**TOWN OF MOUNTAIN VILLAGE
REGULAR DESIGN REVIEW BOARD MEETING
AGENDA
THURSDAY MARCH 3, 2022 10:00 AM
MOUNTAIN VILLAGE TOWN HALL
455 MOUNTAIN VILLAGE BLVD, MOUNTAIN VILLAGE, COLORADO**

4.	10:35	45	Ward/Applicant	Quasi-Judicial	Consideration of a Design Review: Initial Architecture and Site Review for a new Single Family home on Lot 344R, 111 Rocky Rd., pursuant to CDC Section 17.4.11.

TO: Mountain Village Town Council
FROM: Amy Ward, Senior Planner
FOR: Design Review Board Public Hearing; March 3, 2022
DATE: February 23, 2022
RE: Staff Memo – Initial Architecture Review (IASR) Lot 344R, 111 Rocky Road

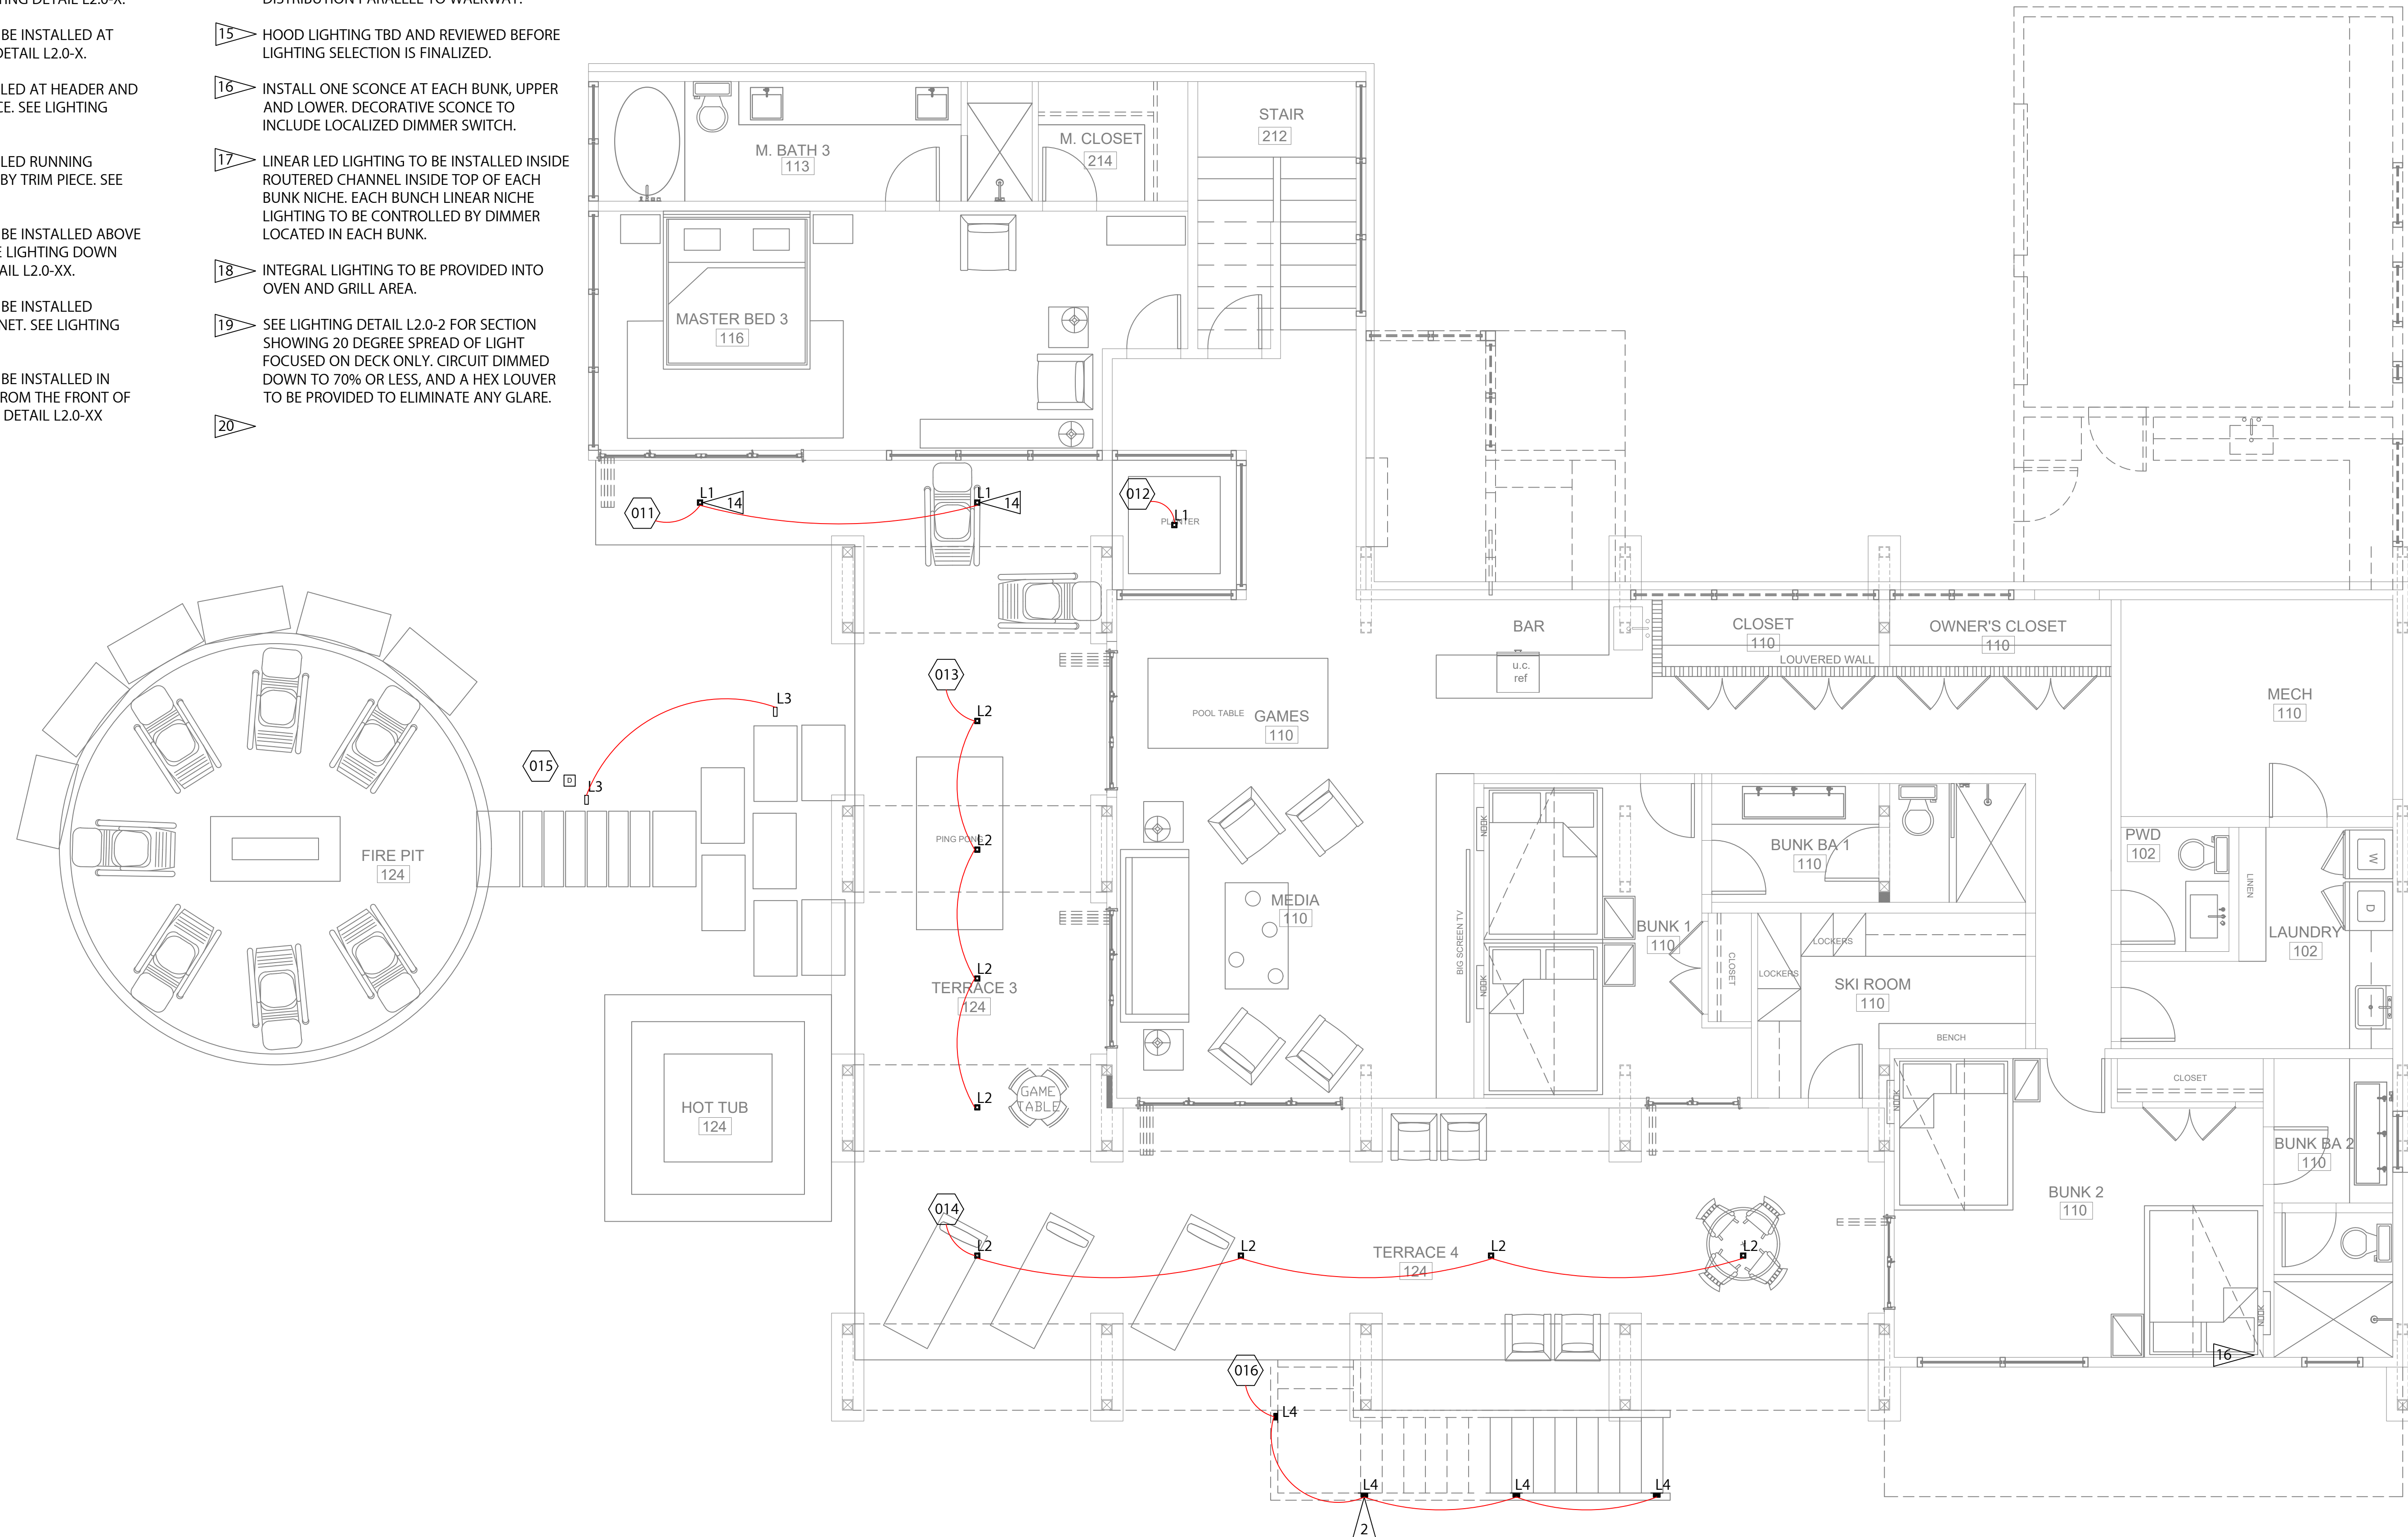
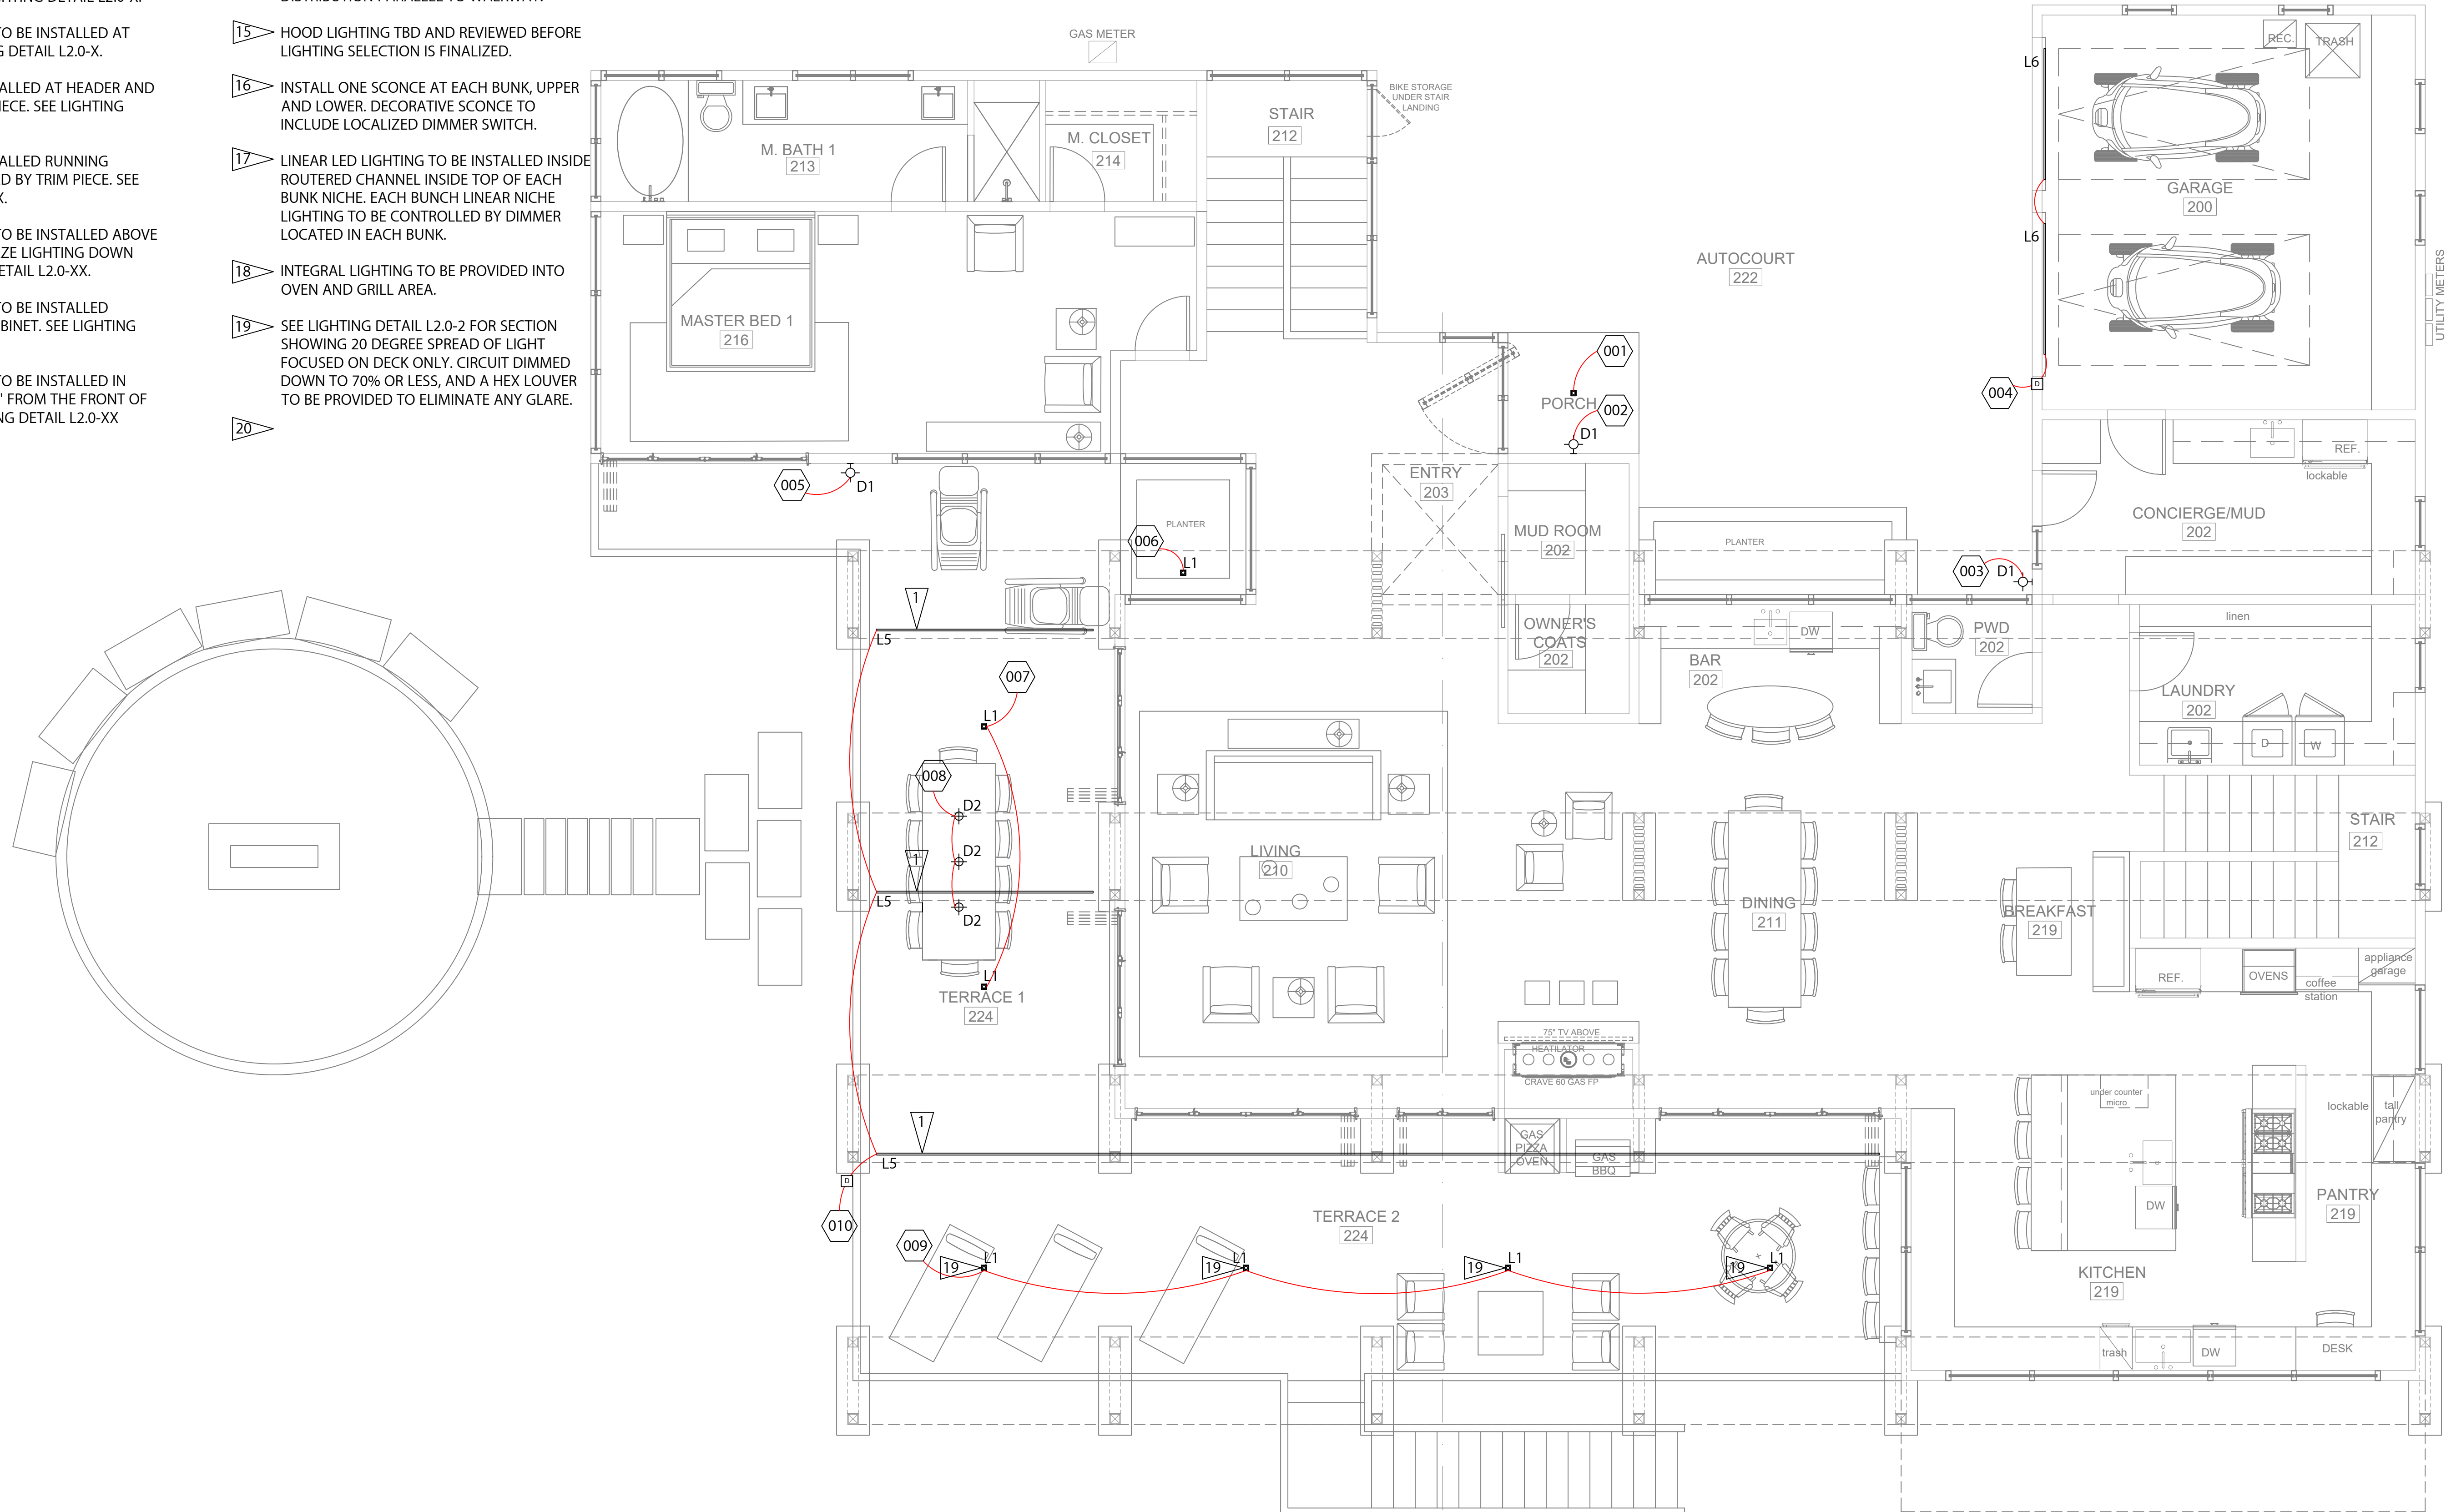
Staff: The applicant has provided a lighting plan and photometric study. Both of the recessed can fixtures as well as the path lighting fixture (fixtures L1, L2 and L3) have lumen output that exceed the max allowable per the CDC. The applicant has specified that the fixtures will be placed on a dimmer system to cap their output. The deck on the NW side of the home has LED strip lighting installed that will wash the underside of the roof deck (see detail at L2.0). DRB seemed to find this detail generally approvable at Initial Review and therefore a specific approval should be granted. It should be noted that since Initial review the applicant has reduced the number of fixtures on the main level deck by five, this should help to reduce the overall visibility of this home from the Mountain Village Core. Additionally, the Ridge Settlement agreement has additional lighting requirements for any lighting fixtures that face east towards the valley floor. The proposed lighting does not include any fixtures that would contradict these requirements.
